Re: Chapter III Corrections and Temporary Coarse  
Refuse Storage Amendment Insertion

Application for Permit Amendment  
for Designation of Temporary Coarse Refuse Storage Area  
within Currently Disturbed Areas

Sunnyside Coal Company  
Permit ACT/007/007

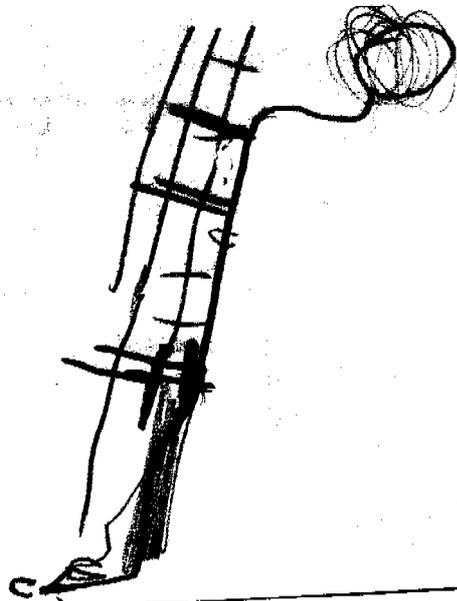
Amendment needed:

Ponds.

- Culverts sized (Ditch Design)
- Pond okay
- Correct Plate III - 5a (not as shown)
